SUBJECT: Initial review of Planned Rezoning Overlay (PRO) eligibility of the request of Novi-Ten Associates, for JZ23-09 Novi Ten PRO for a Zoning Map Amendment from Light Industrial (I-1) and Office Service (OS-1) to Low Density Multiple Family (RM-1) and General Business (B-3) with a Planned Rezoning Overlay. The subject site is approximately 34-acres and is located east of Novi Road, south of Ten Mile Road (Section 26). The applicant is proposing to develop a 71-unit multiple-family townhome development on the RM-1 portion, and approximately 35,900 square feet of commercial space on the B-3 portion. Under the PRO Ordinance, this initial review by City Council is an opportunity to review and comment on the eligibility of the proposal and offer feedback.

SUBMITTING DEPARTMENT: Community Development Department - Planning

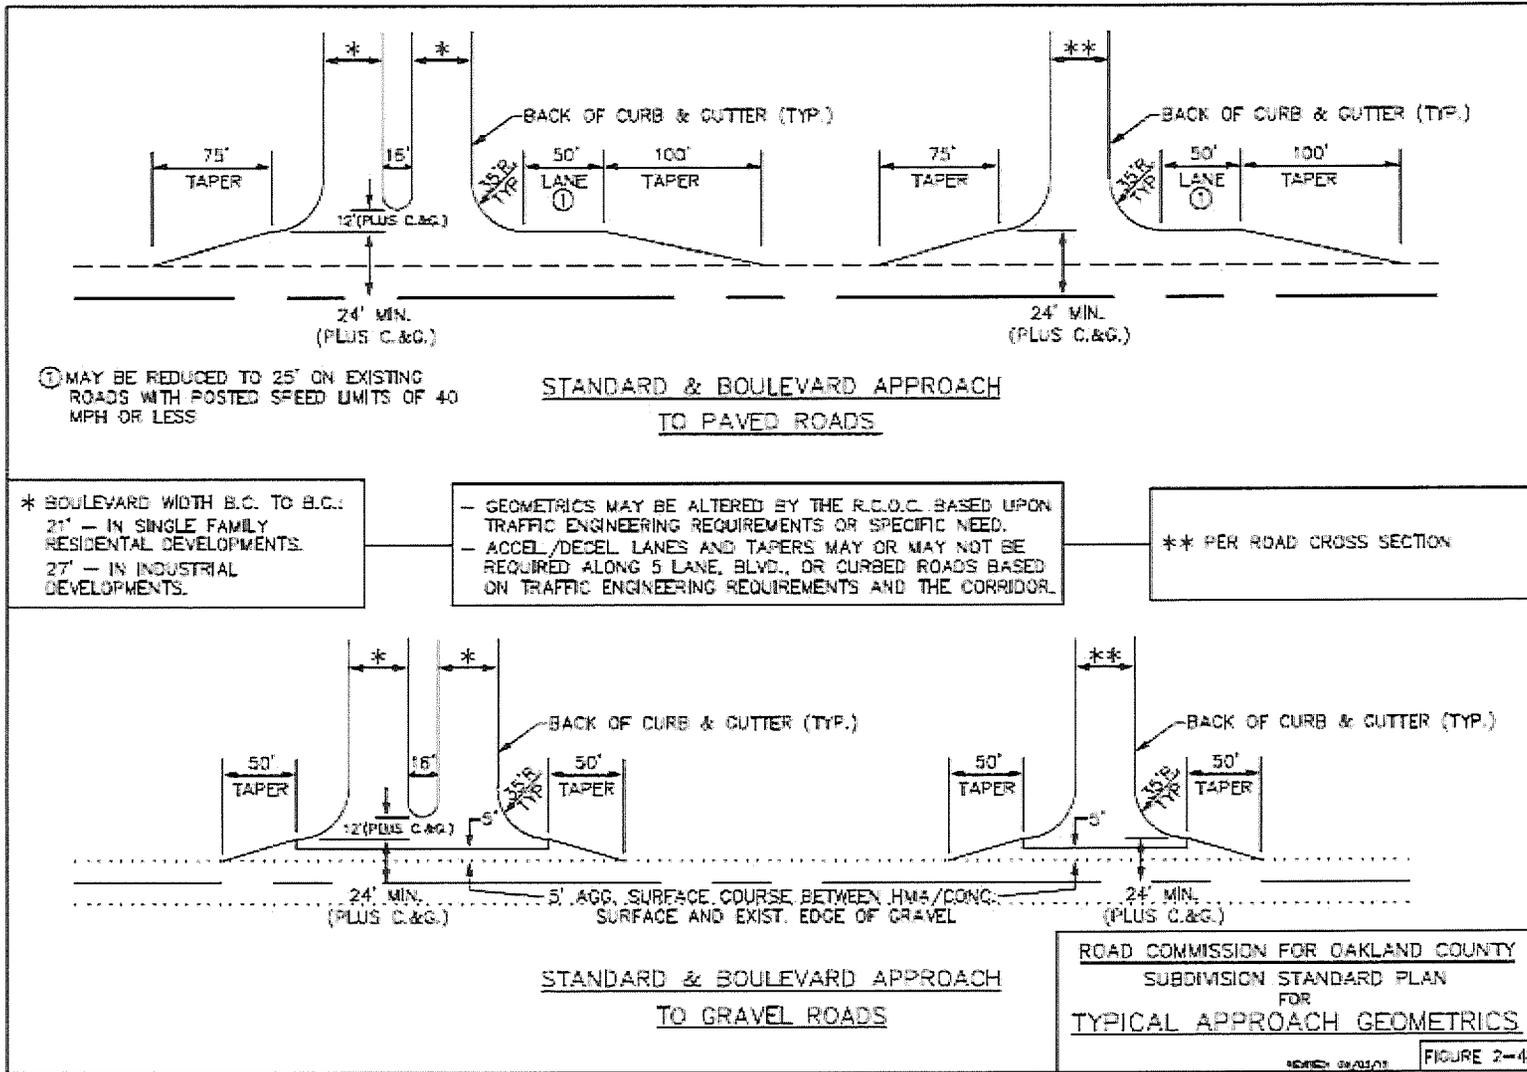
Carry 5-Lane cross section to just past double driveway.

WB Lane begins just east of that 2nd driveway with the driveway radius 35', 50' lane, and 100' taper.
